PLAN COMMISSION	ON AGENDA	ITEM EXECUTIVE SU	MMARY
	Project Title/Address:	Concept Plan	for Woodward Court	
THE	City Staff:	Ellen Johnson, Planner		
ST. CHARLES	PUBLIC HEARING 3/17/15		MEETING 3/17/15	X
APPLICATION	:	Concept Plan		
ATTACHMENT	S AND SUPPORTING DO	CUMENTS:		
Staff Report		Plan documen	nts	
Concept Plan Application, received 2/18/15		Excerpts from Ordinance No. 2006-Z-4

RE: Woodward Court Concept Plan

RE: Woodward Court Concept Plan

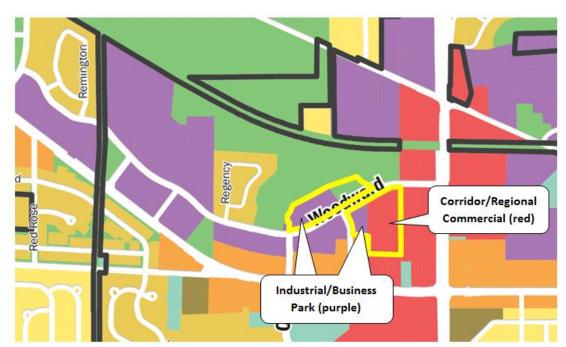
- Public sidewalks are required along the complete frontages of Woodward Dr. and Barbara Ann Dr. Some of the proposed private sidewalks around the buildings can be relocated to function as public sidewalks.
- Demarcated crossings should be added at the intersection of Woodward Dr. and Barbara Ann Dr. to allow safe pedestrian access between the northern and southern portions of the development.
- The applicant should consider reducing the number of access points along Woodward Dr. to minimize the potential for traffic conflicts. This will need to be studied as part of the traffic study that will be required.
